UNITED STATES PATENT AND TRADEMARK OFFICE

APPLICATION NO.	FILING DATE	FIRST NAMED INVENTOR	ATTORNEY DOCKET NO.	CONFIRMATION NO.
10/643,862	08/19/2003	Michael J. Pugia	017191.0036 (MSA-3459)	5515

Office Action Summary

DETAILED ACTION

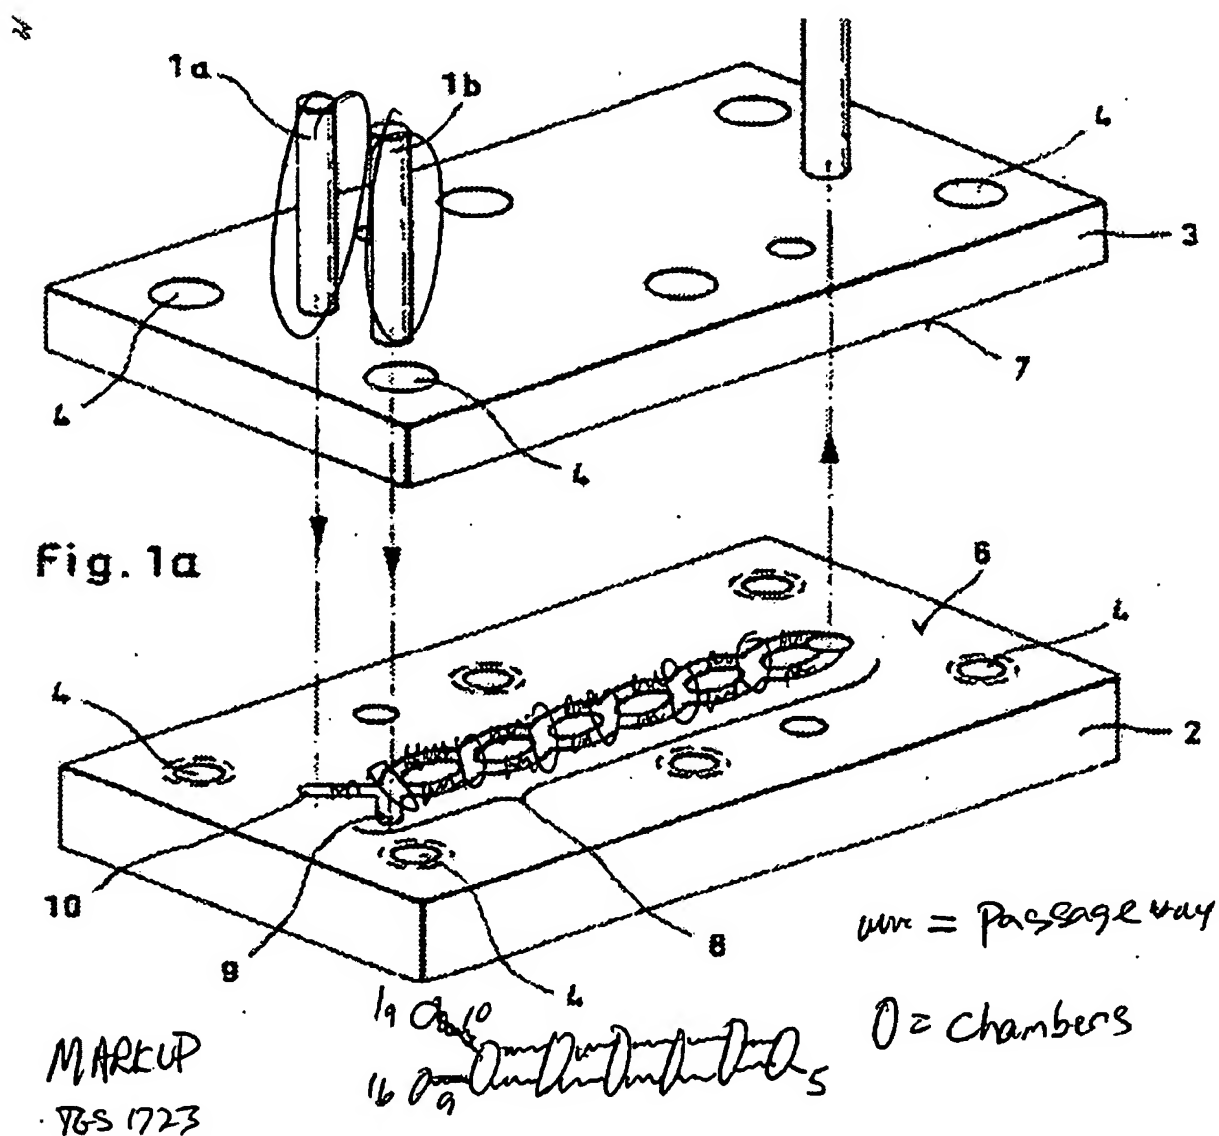
5. Claims 1-2, 4, 20, and 21-22, and 24, are rejected under 35 U.S.C. 102(e) as being anticipated by Koop et al US 6457854 (cited on PTO 1449).

The Koop reference discloses an apparatus and method of use for mixing fluids including two inlets for a 1st and 2nd fluid wells to be fed into a 1st chamber at the intersection of 9,10, a second chamber through seventh at the intersection of the sinusoidal loops which are microchannel capillary passageways along the portion 8, see figure 1, which ends at an outlet chamber at 5 for further processing, whereby each loop side may be deemed as separated passageways. It is noted that one may define any subsequent volume of liquid dispensed from the source wells 1a and 1b as a volume per unit time to be mixed together and one may deem the time unit so small that

11. Applicant alleges that the Koop reference does not show 1st and 2nd chambers connected through capillary passage ways. Applicant is referred to the rejection made above in section 5 and refer to the mark up drawing.
